**HVAC Replacement for
Summit Drive Elementary School
Greenville County School District**

Solicitation No: **124-33-9-29**

Addendum No. 2

DATE: October 12, 2023

M-5

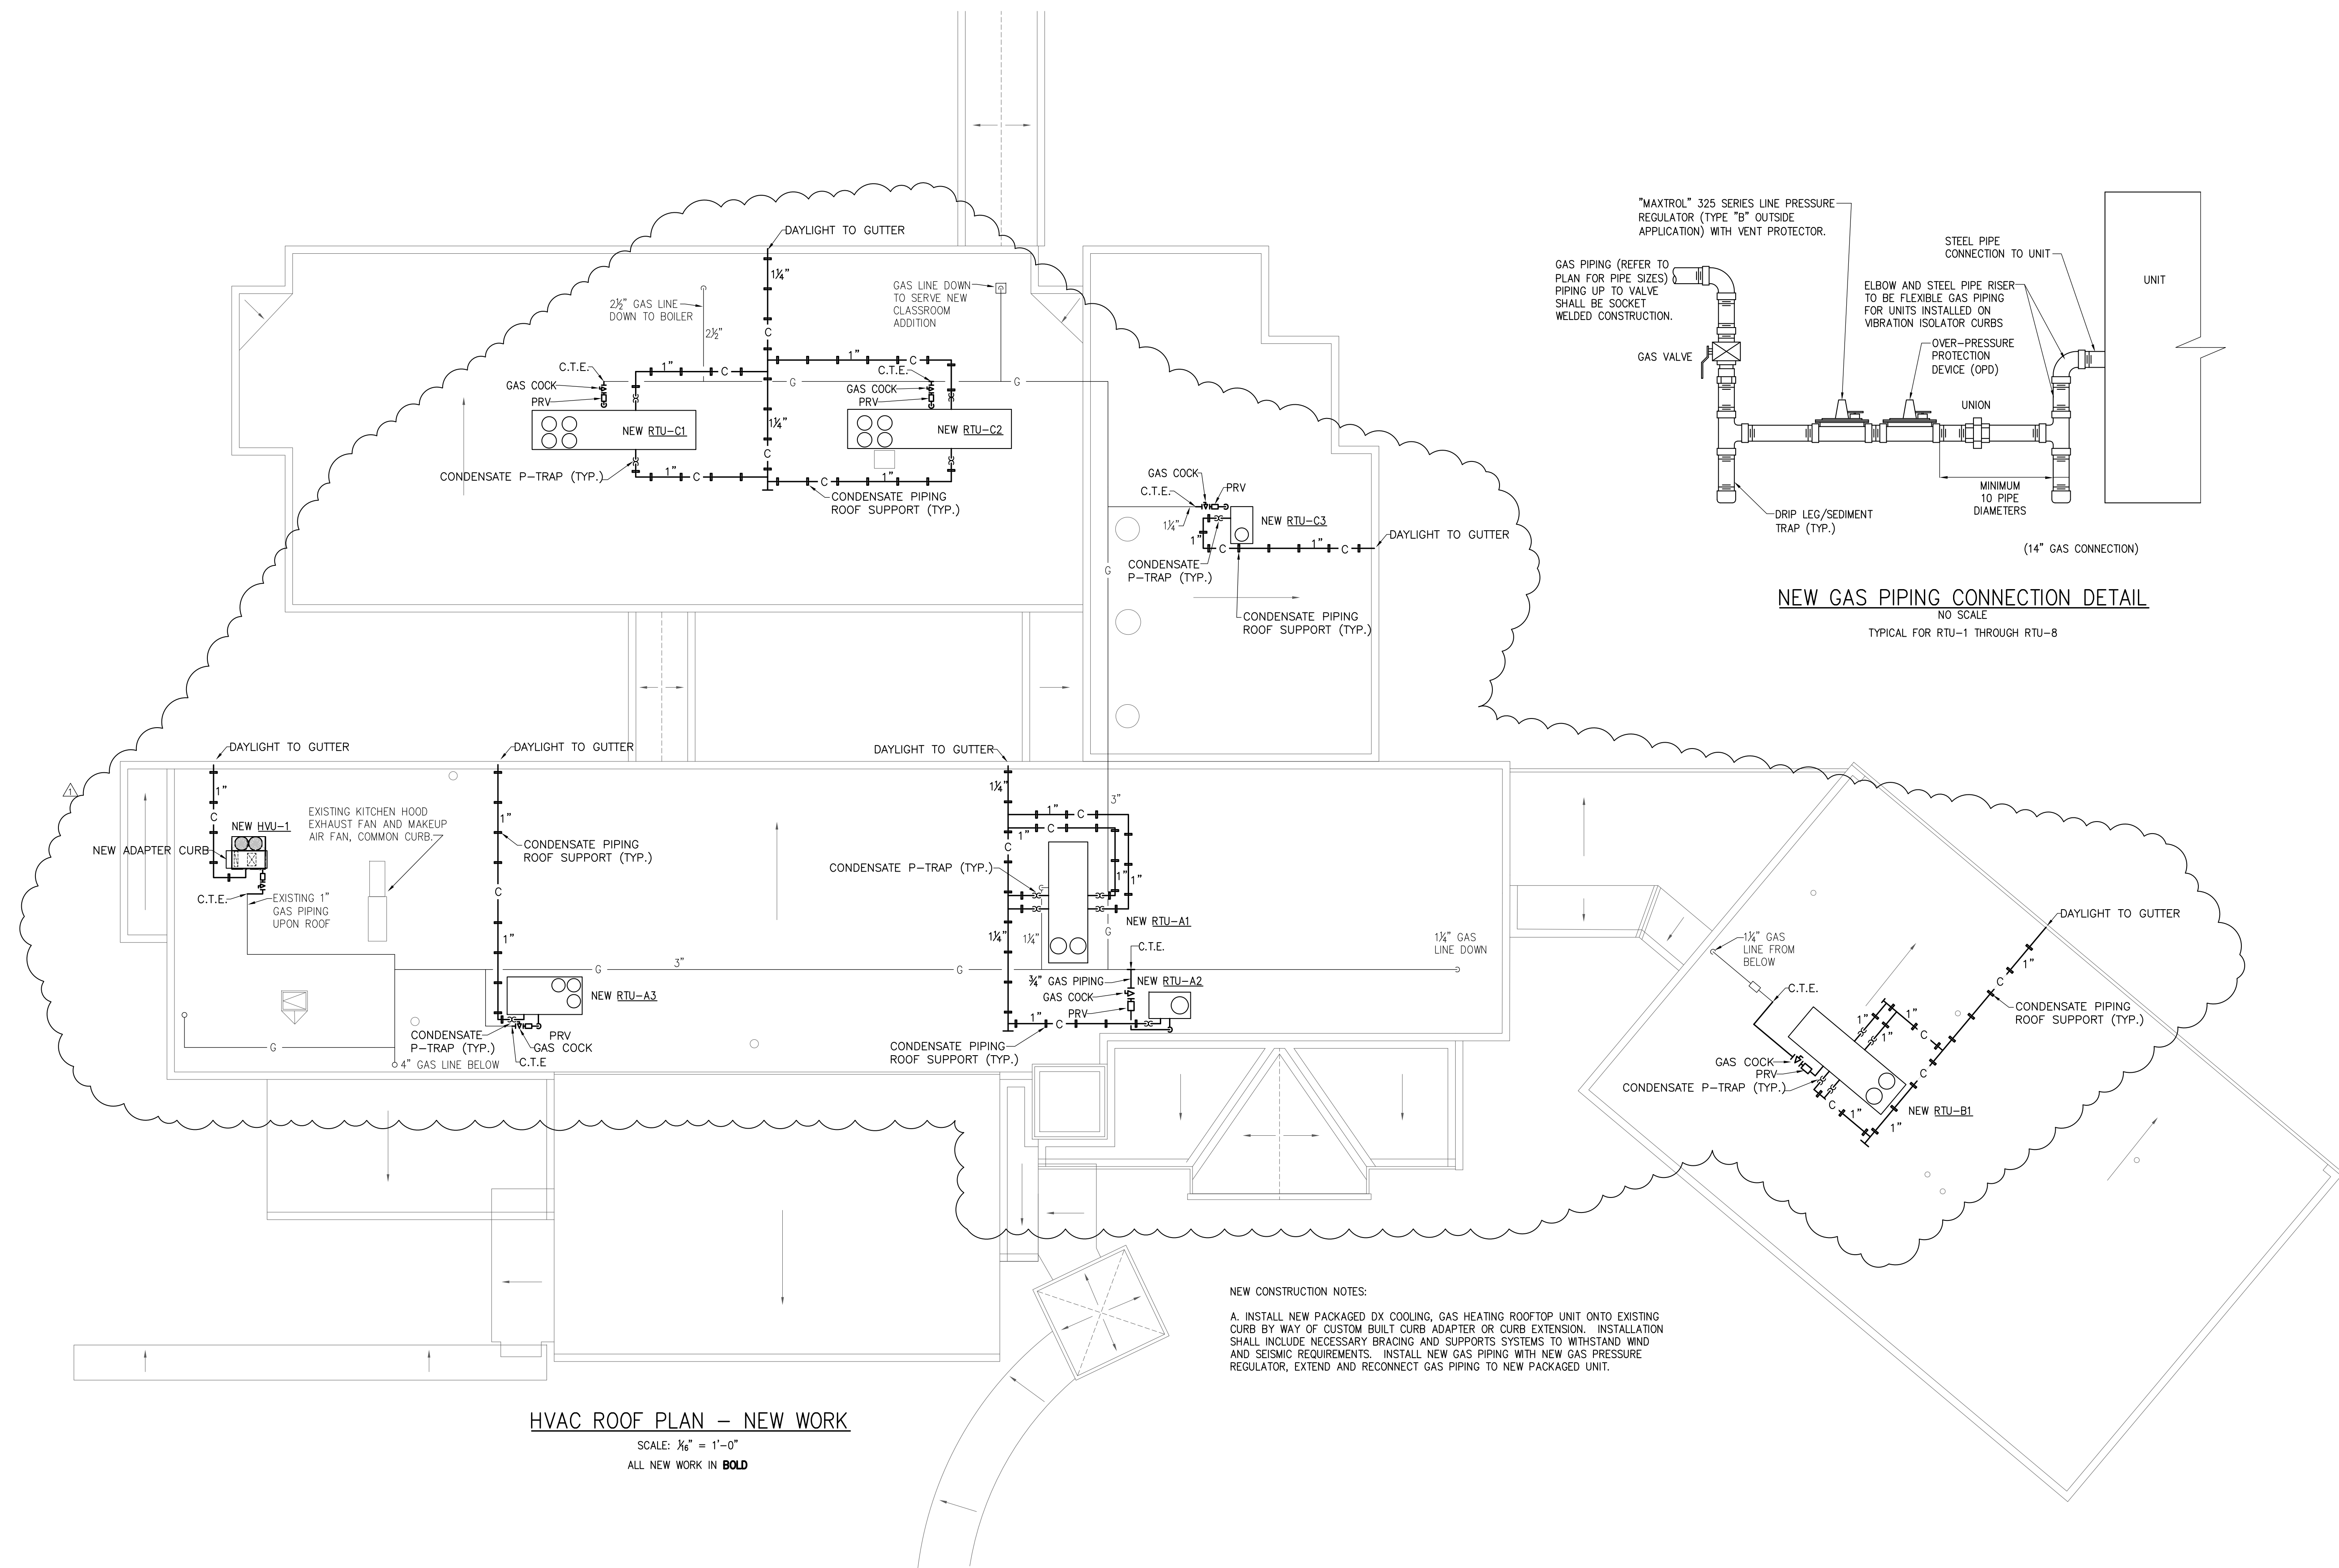
4. M-5, HVAC Roof Plan, Added new kitchen ventilation unit HVU-1 and adapter curb, and updated gas piping and condensate drain piping.
5. M-6, HVAC Schedules & Details, Added kitchen ventilation unit HVU-1 schedule and updated equipment schedule notes.

DESIGN: RAB
 CHECKED: PEK
 DATE: 9-12-23
 PERITUS JOB NO. 221202
 SHEET E-1

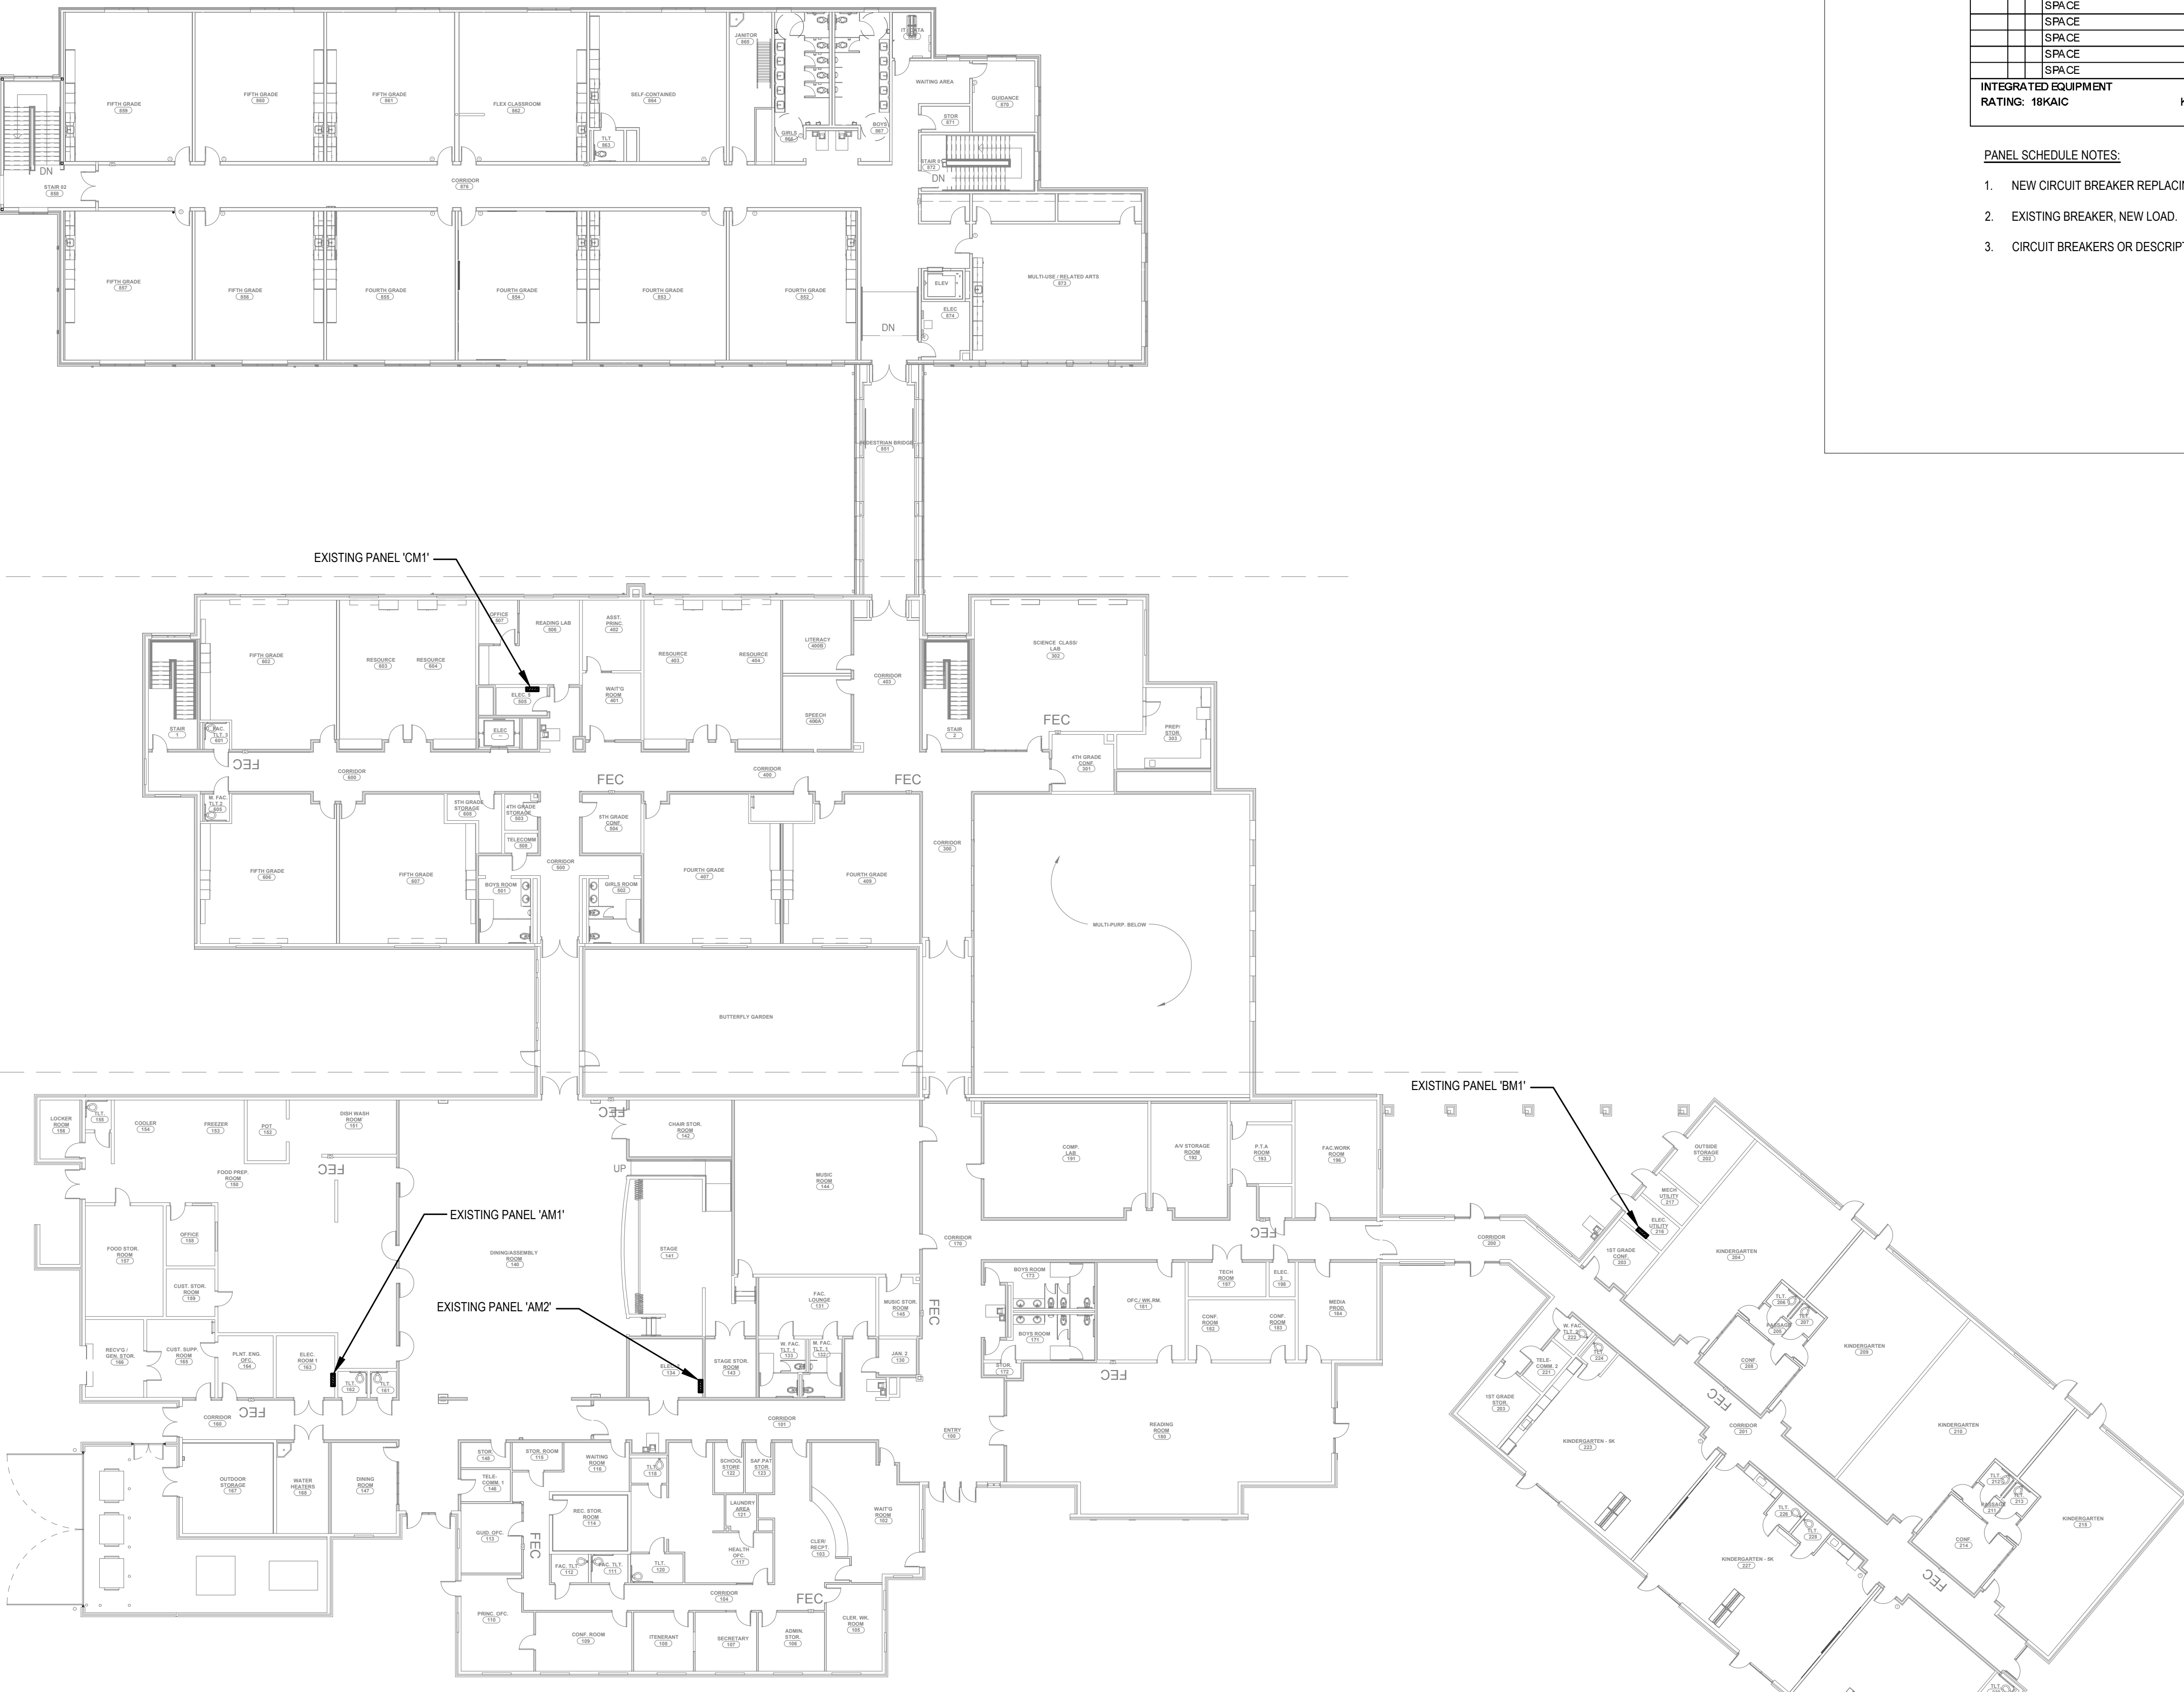
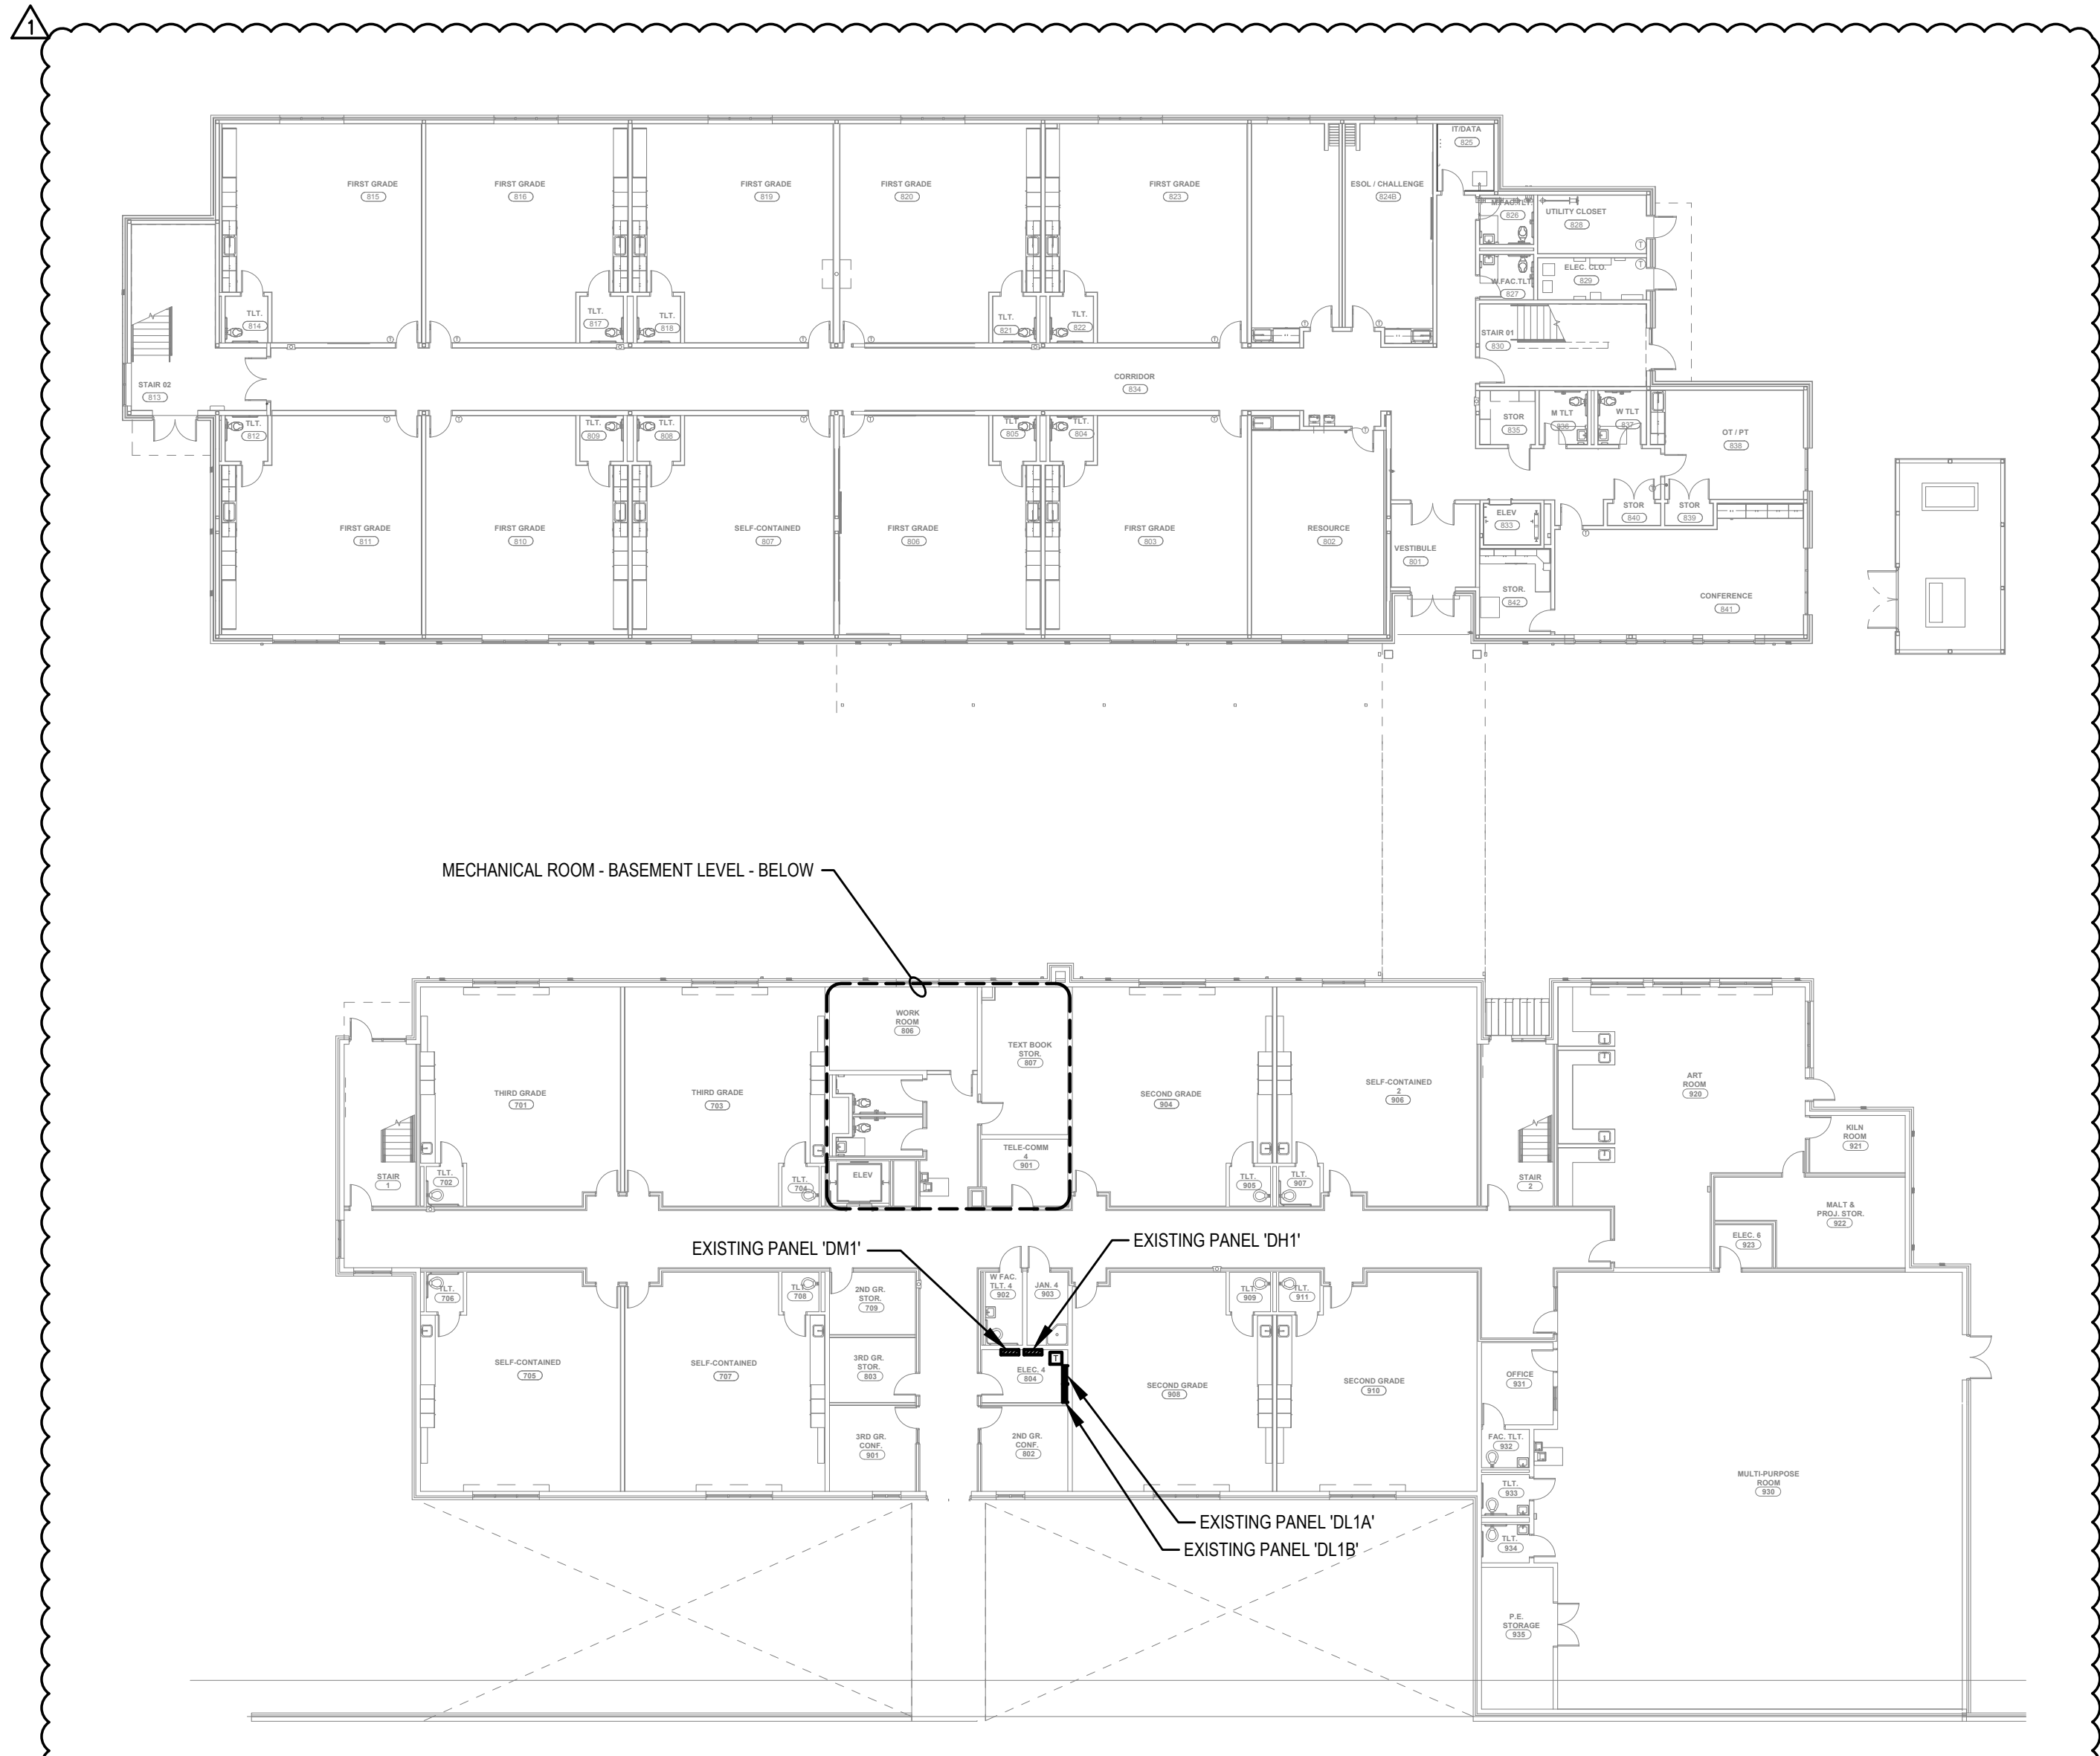
6. E-1, Electrical Legend, and Schedules, Added basement level plans and breaker for new Roof Mounted HVU-1 unit.
7. E-2, Electrical Overall Equipment Power Plan, Added power to new Roof Mounted HVU-1 unit. Added basement plan and power connections to replacement boilers and pumps.
